### ADDENDUM NO. 1

To the Drawings and Project Manual dated 16 June 2017

**TAS/ADA FIRE MARSHAL  
DEFERRED MAINTENANCE PROJECTS  
MIDWESTERN STATE  
UNIVERSITY**

Addendum Date: 2 August 2017

**BOLIN SCIENCE HALL - FIRST FLOOR - AREA 1C**  
**ELECTRICAL DEMOLITION PLAN**

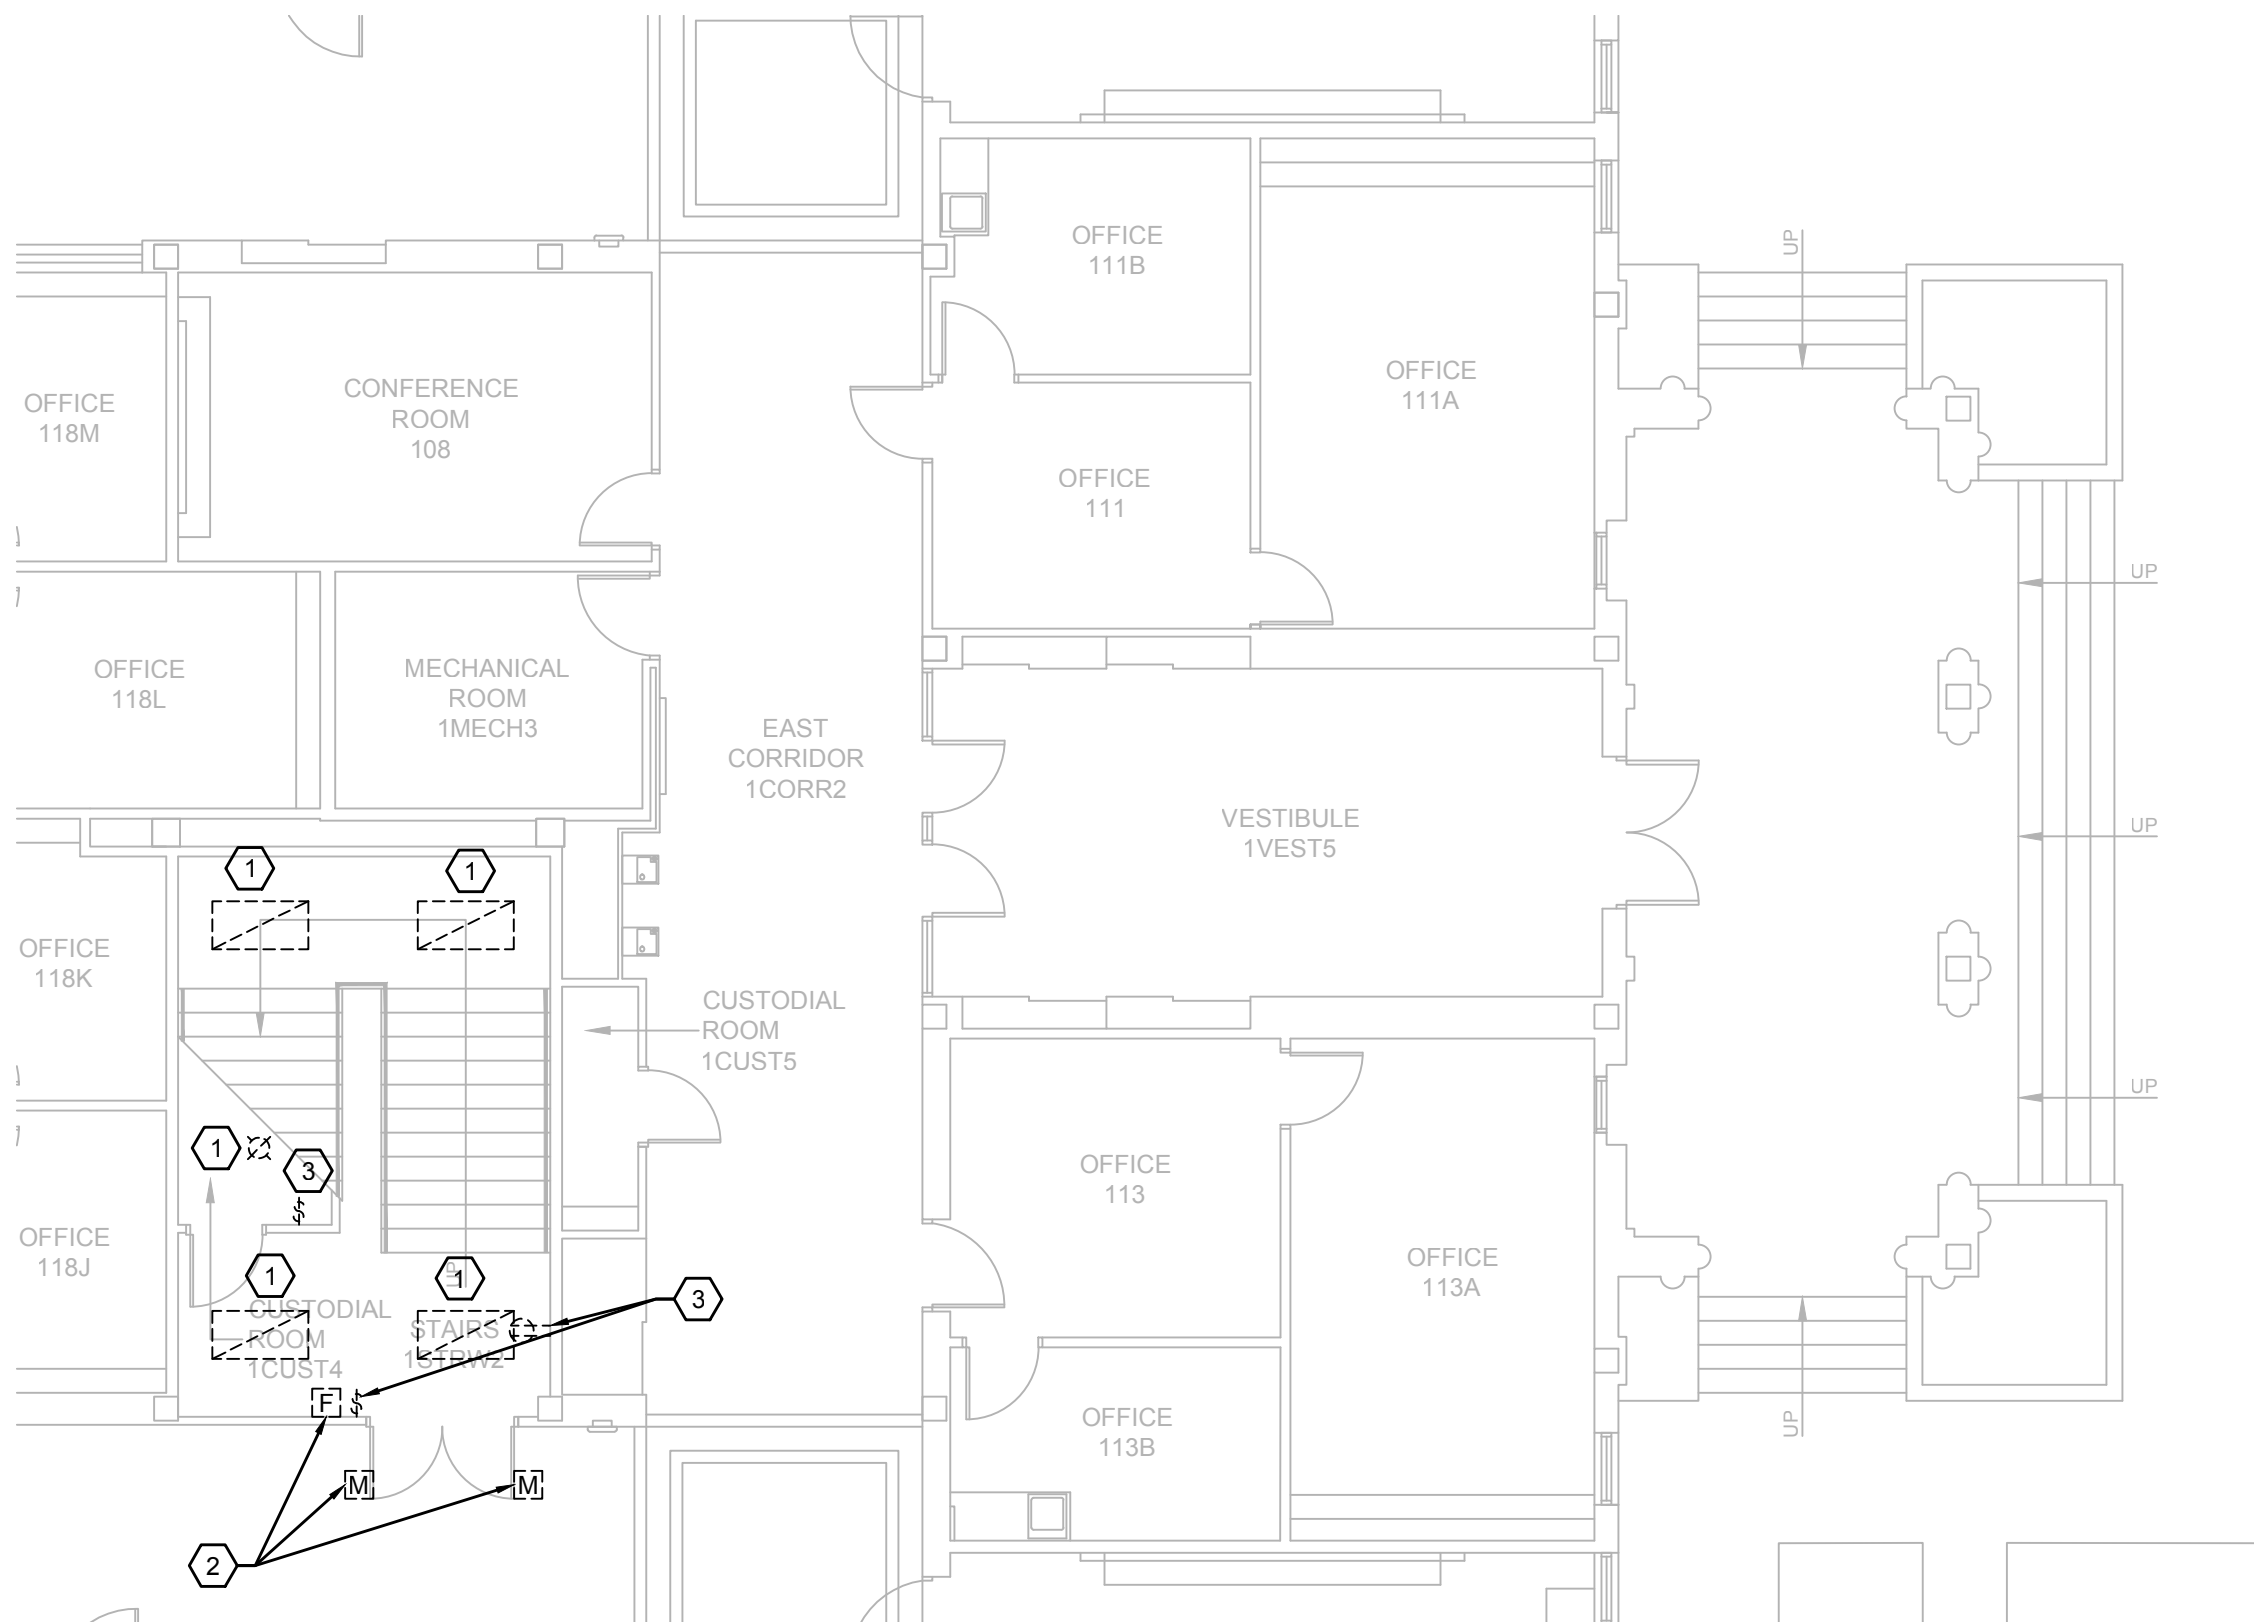
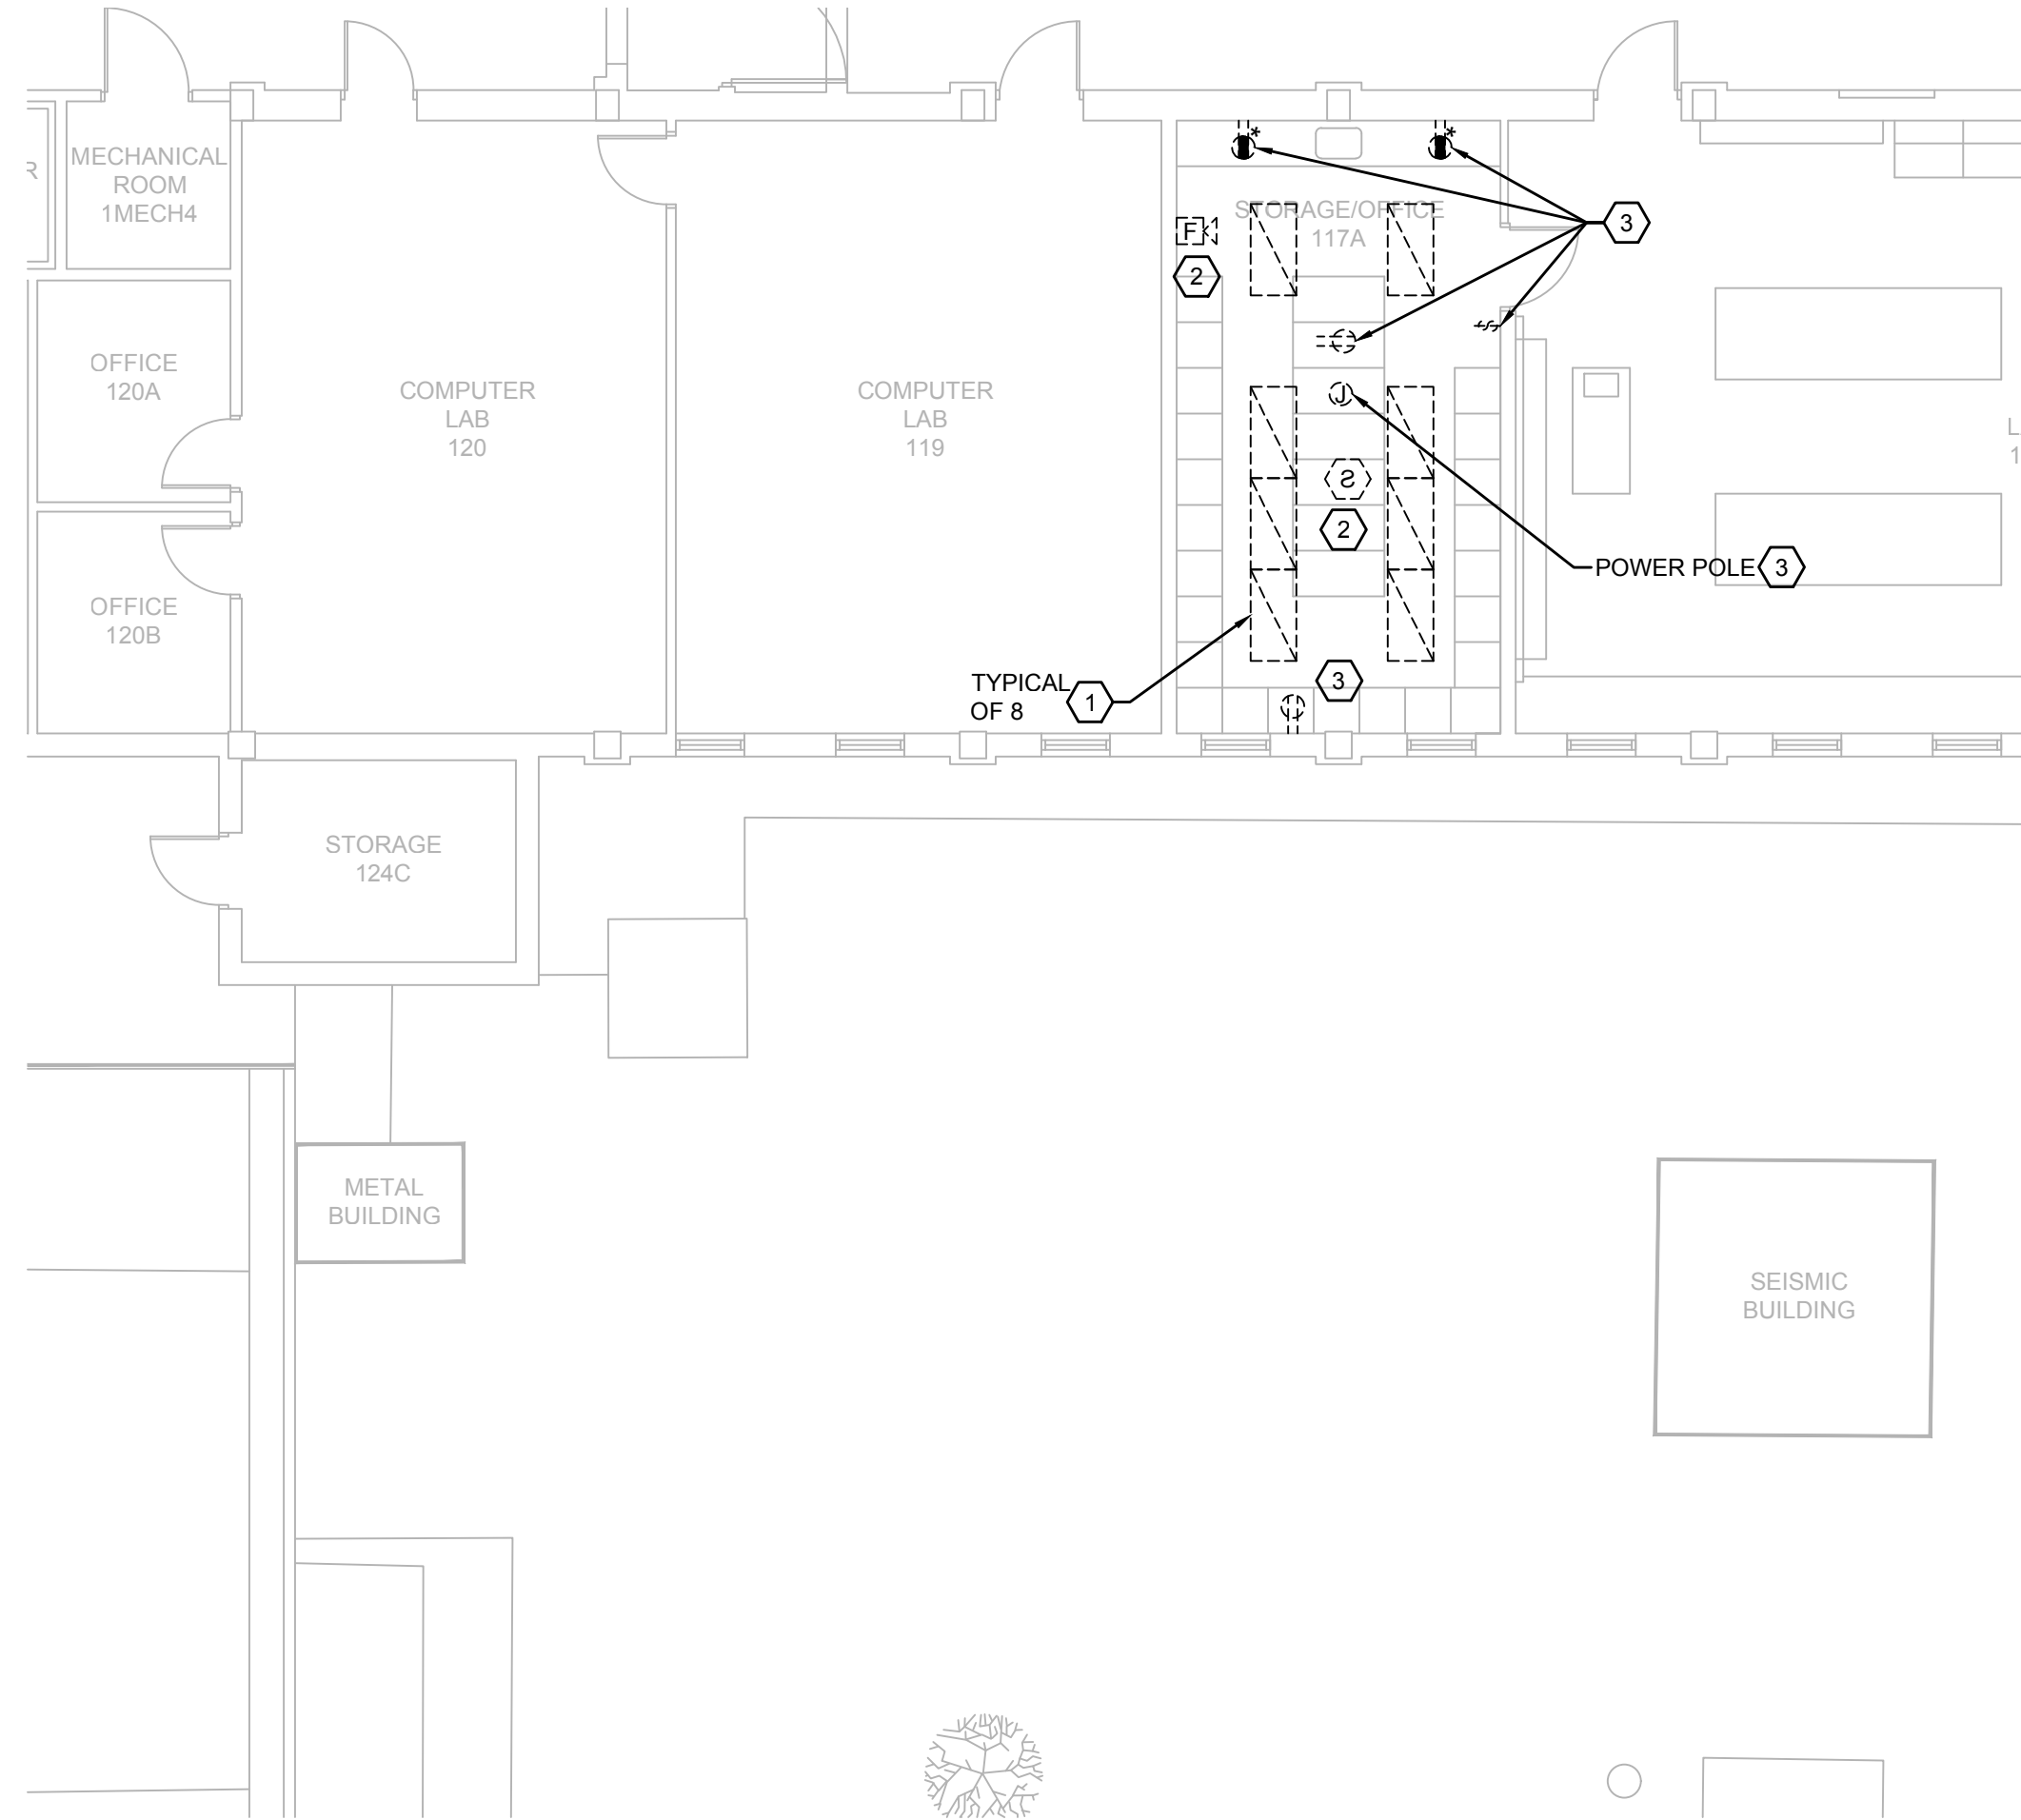
1. Sheet B-ED101 – Revised Drawing as follows:
  - a. Modify Key Note #5 to clarify existing transformer to be removed does not contain PCB.
  - b. Modify Key Note #7 by deleting “prior to demolition”
